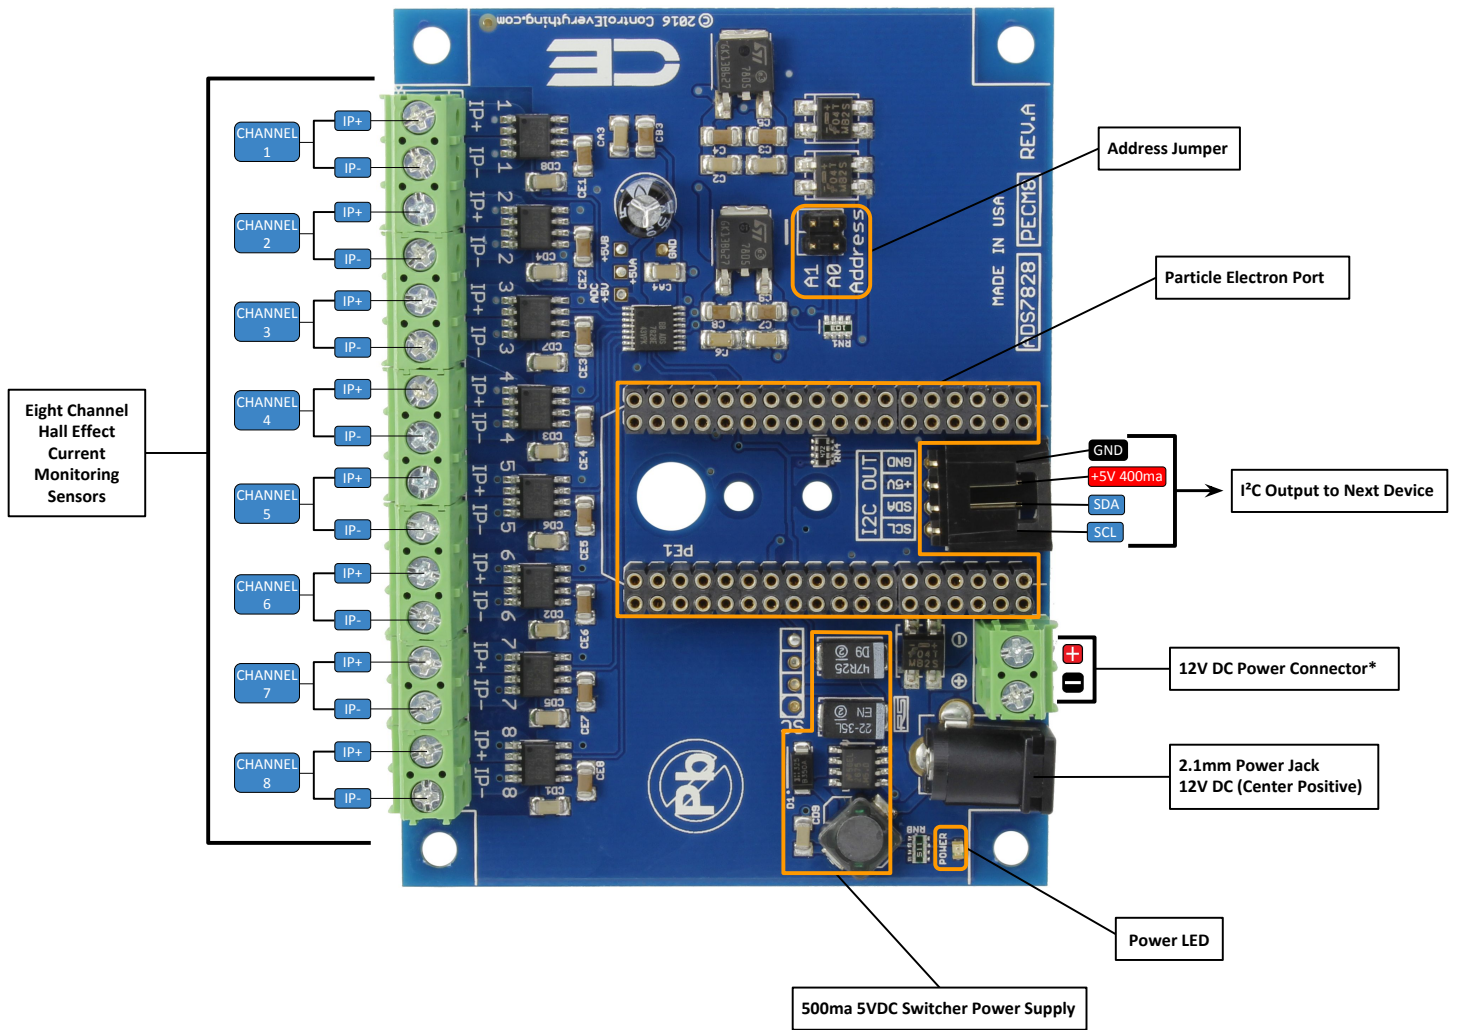
***NOTE:**
Revision A & B Boards have a labeling error indicating + and - connections on the power terminal block. The labeling on this page is correct for all revisions. Revision C boards have been corrected for proper PCB labeling. This controller is polarity protected and will not be damaged by incorrect power connections.
